Model 225H

Filter cover

05-96 STG14004

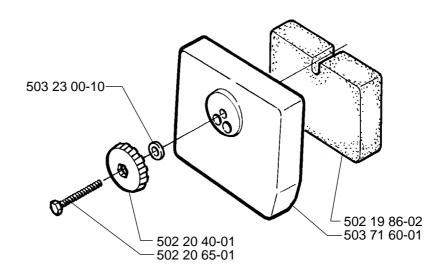
Two holes have been introduced into the filter cover to improve the air flow through the air filter. Washer 503 23 00-10 has been added to create a gap between the knob and the filter cover. This washer will soon be superseded by a spacer integrated into the filter cover.
